Date: July 14, 1992

Subject: Feedback on "PA Modeling Using BRAGFLO -- 1992" 7-8-92 memo by J. Schreiber

PA Modeling Using BRAGFLO -- 1992

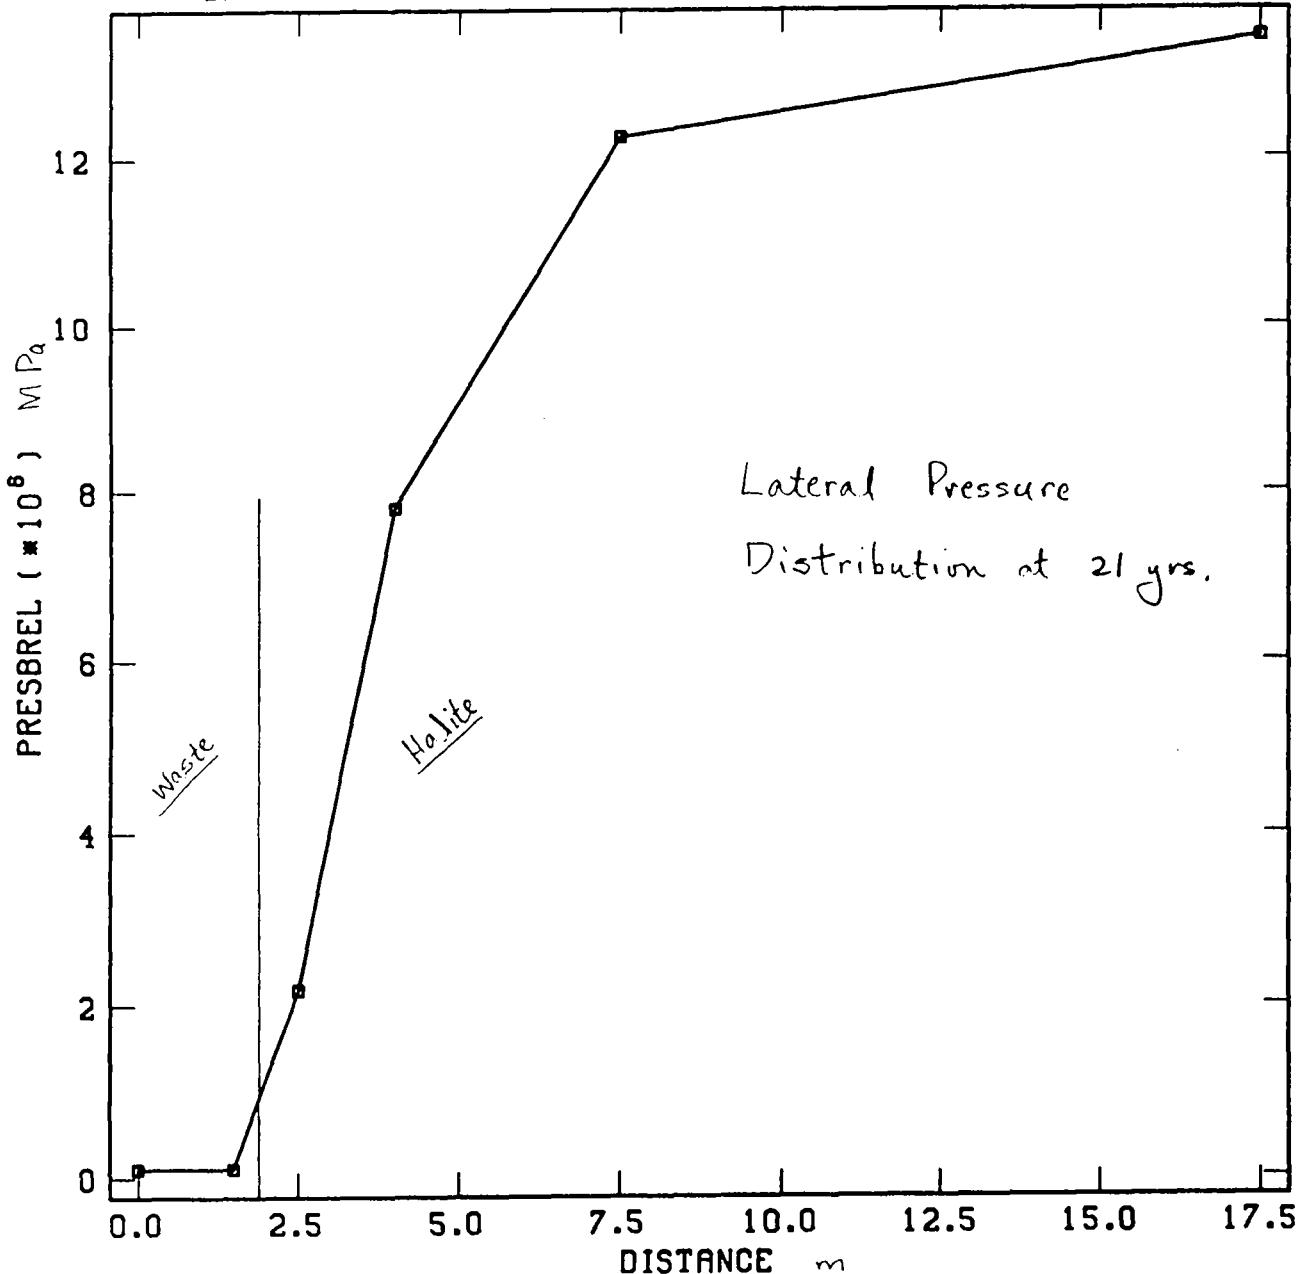
2. The illustration of the model configuration is somewhat confusing in that it gives the appearance that the anhydrite interbeds start at the lateral edge of the DRZ and transition zones. Perhaps these schematics would benefit by showing how the geologic units fit into the model zones.

1992 Undisturbed Anhydrite Permeability

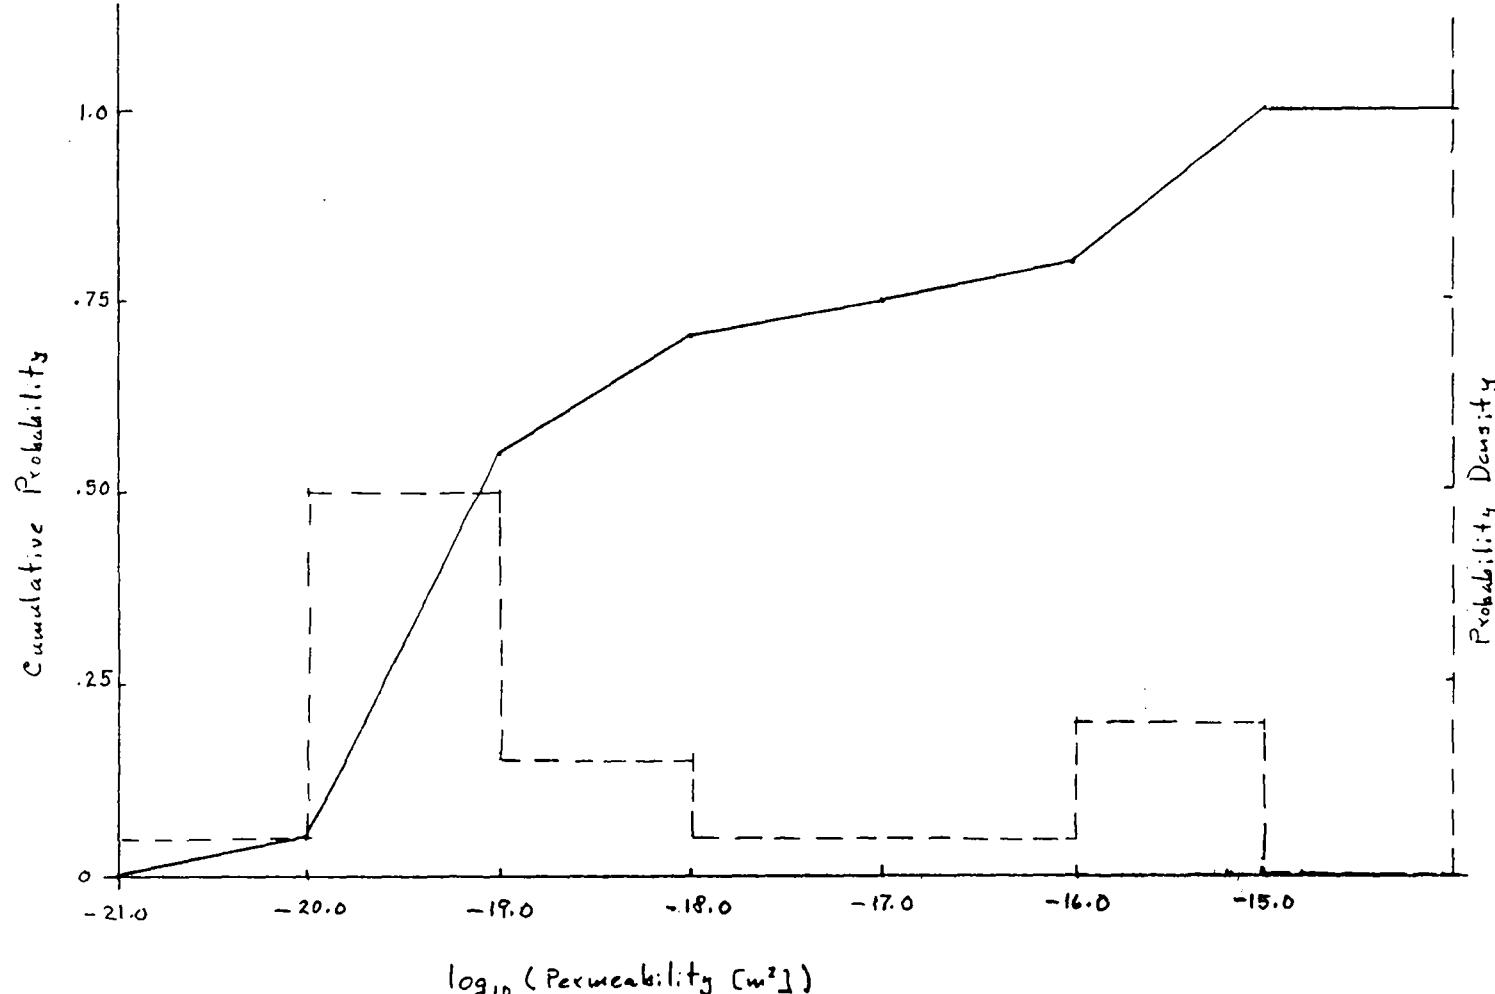
6. We (6119 and 6342) have not yet reached good closure on the question of the far field permeability distribution for the anhydrite interbeds. The original recommendation (model configuration and parameter distributions transmitted to PA 4-1-92 by E.D. Gorham) was to use only permeability values from a limited number of tests (3) in non-depressurized anhydrite. This approach assumed that the PA model for the 1992 calculations would be capable of including increased permeability due to fracture dilatation in response to elevated gas pressures. When it became apparent that fracture-based permeability changes will not be available in the '92 models, it was recommended that an attempt be made to crudely incorporate the effects of gas-driven increases in fracture permeability by specifying a much larger far-field permeability range for the anhydrite that included not only the non-depressurized tests, but also the group of tests in depressurized but substantially intact anhydrite and the group of tests in anhydrite that has experienced substantial fracturing in the DRZ (E.D. Gorham 6-15-92 memo). This approach was considered unrealistically conservative by performance assessment personnel in the June 25th meeting and a compromise was reached that 1) the performance assessment calculations will not attempt any representation of the interbed fracture process in the '92 calculations; 2) that explicit caveats will be placed visibly in the report that this potentially significant process was not included in the calculations; and 3) the field permeability for the anhydrite interbeds will be represented by the small group of tests in non-

depressurized anhydrite interbeds together with the much larger group of tests in depressurized but substantially intact anhydrite. While this compromise appears to be acceptable to most people, it should be recognized that this distribution is not without potential flaws that could perhaps be corrected if there were sufficient time to construct a new distribution that focused on capturing the uncertainty in whether or not some of the tests in the depressurized but substantially intact anhydrite have in fact experienced significant permeability enhancing deformation. Given the present time constraints, we suggest that the compromise distribution be used, but that it be recognized that this distribution is not without potentially important flaws.
